Agenda
City of Charlottesville
Board of Architectural Review
Regular Meeting
June 22, 2022, 5:30 p.m.
Hybrid Meeting (In-person at CitySpace and virtual via Zoom)

Regular Meeting

Footprint

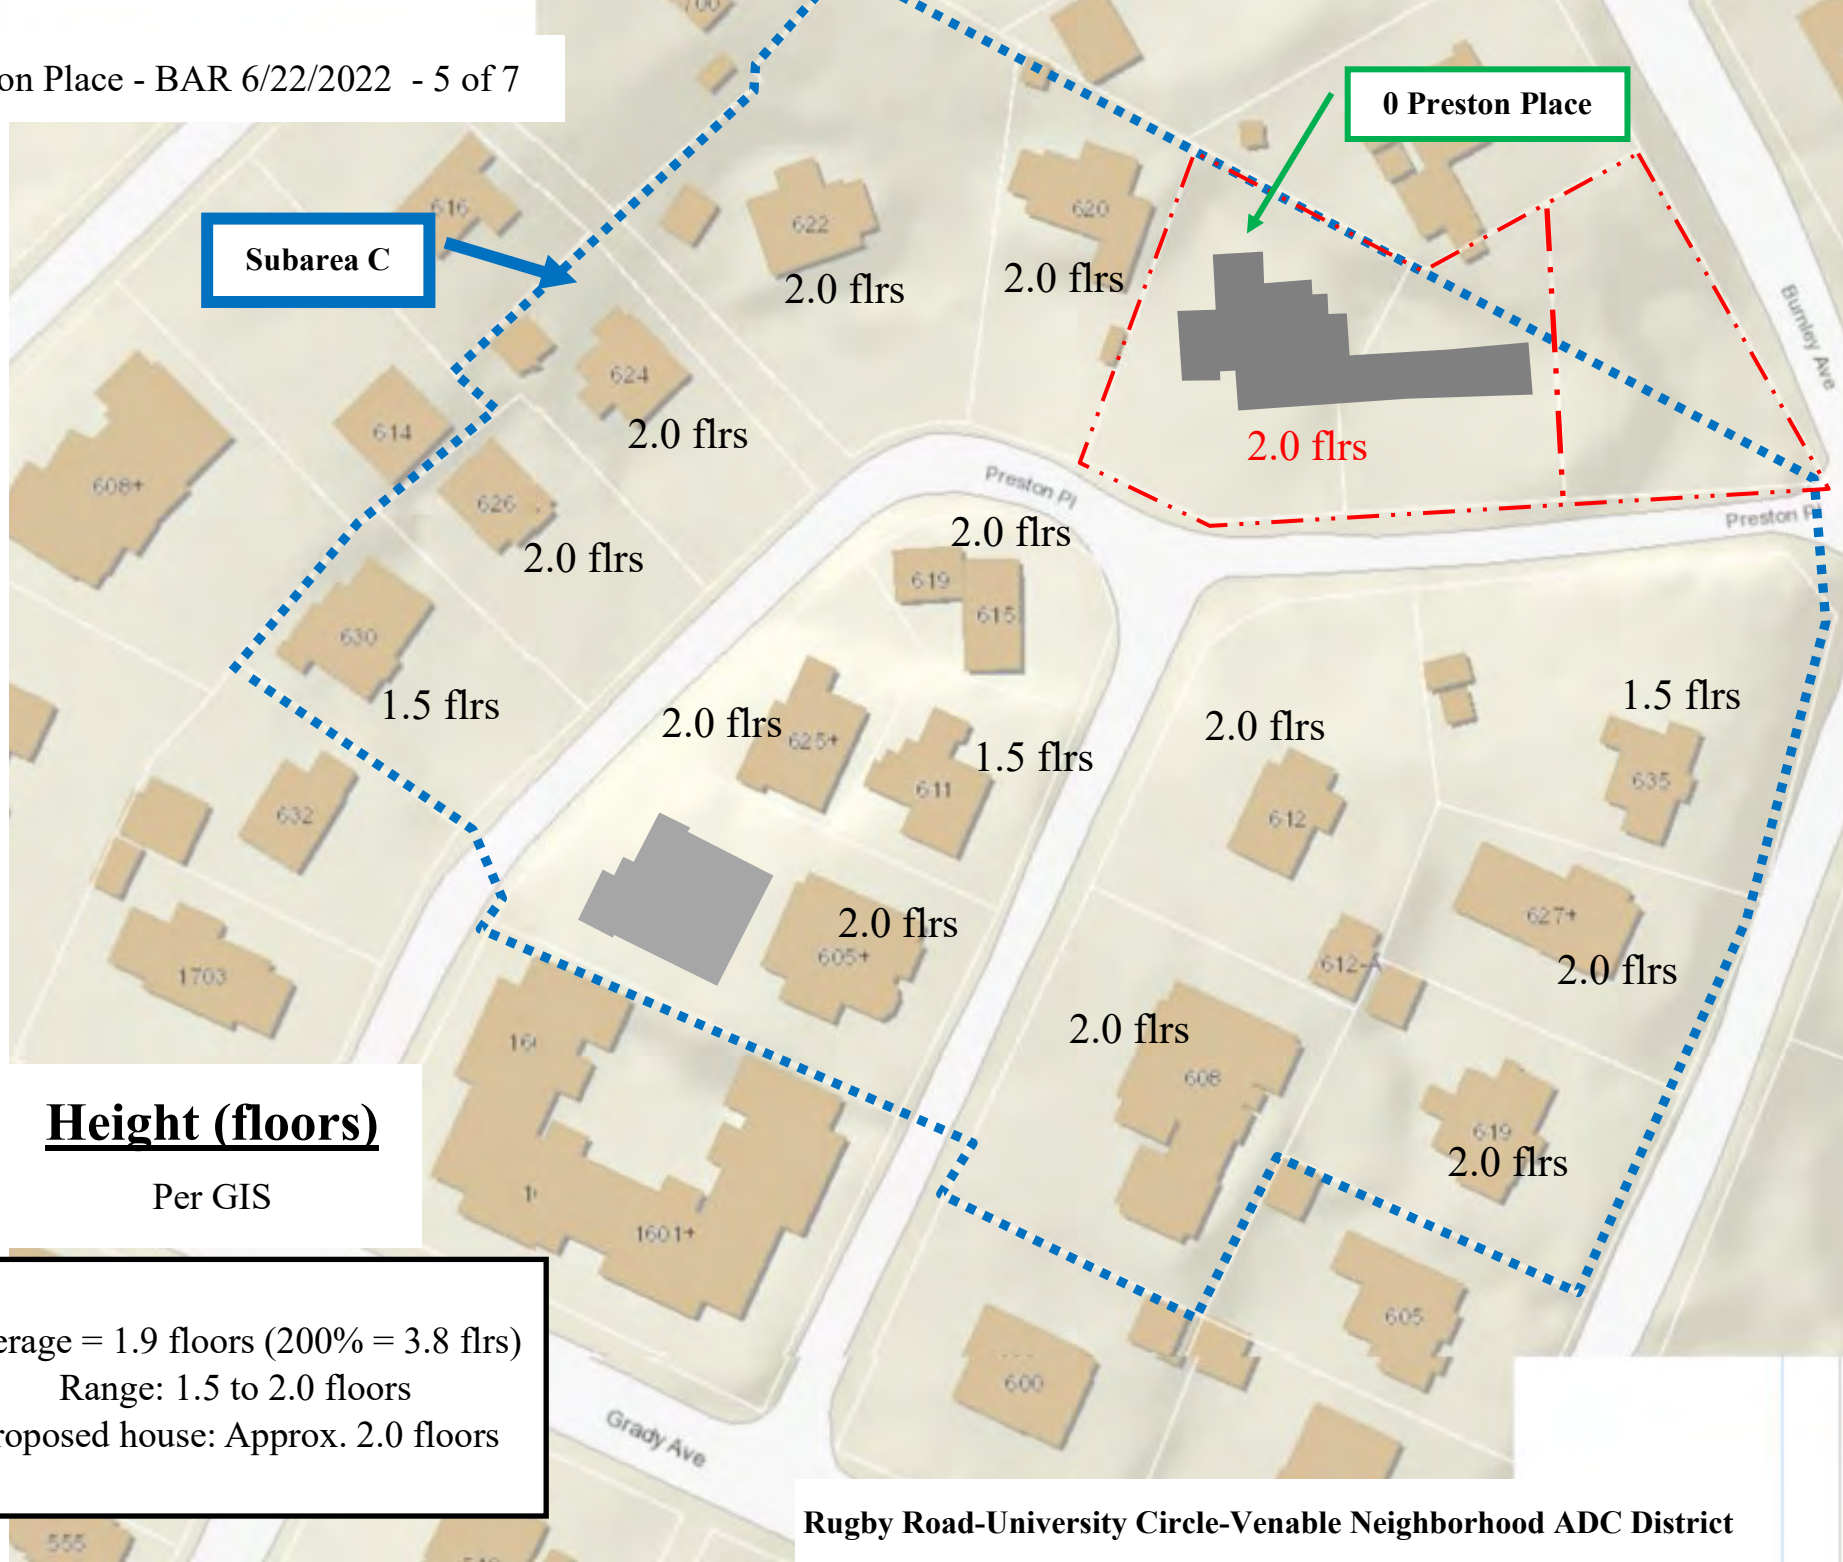
- (Footprint) Existing footprints range between 1,389 square feet to 5,218 square feet. Average is 2,234 sq ft. Footprint of proposed house is approximately 4,800 square feet and within the range of the subarea.
- (Massing) The proposed house, viewed from the street, is wider than average and exceeds the maximum; however, its two-stories are the same as 10 of the 14 houses in the subarea, its large footprint visually reads as four individual structures (see the perspectives on sheet S1.2), and as summarized below, other elements such as materials, color, and landscaping will mitigate the massing.

Average = 2,234 sq ft
Range: 1,389 sq ft to 5,218 sq ft
Proposed house: Approx. 4,800 sq ft

Width (facing street)

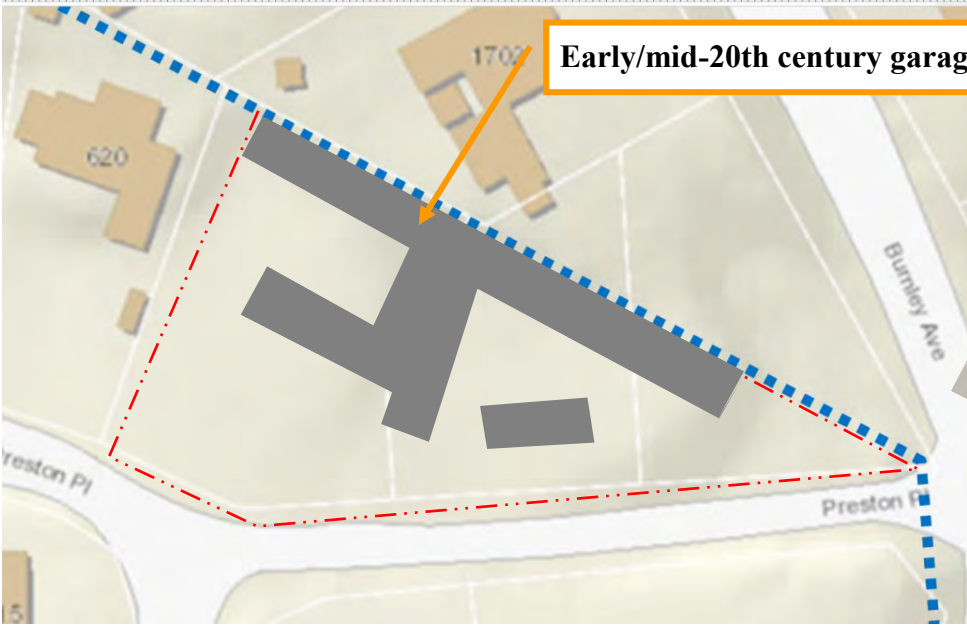
Average = 55 ft
 Range: 34 ft to 106 ft
 Proposed house: Approx. 156 ft
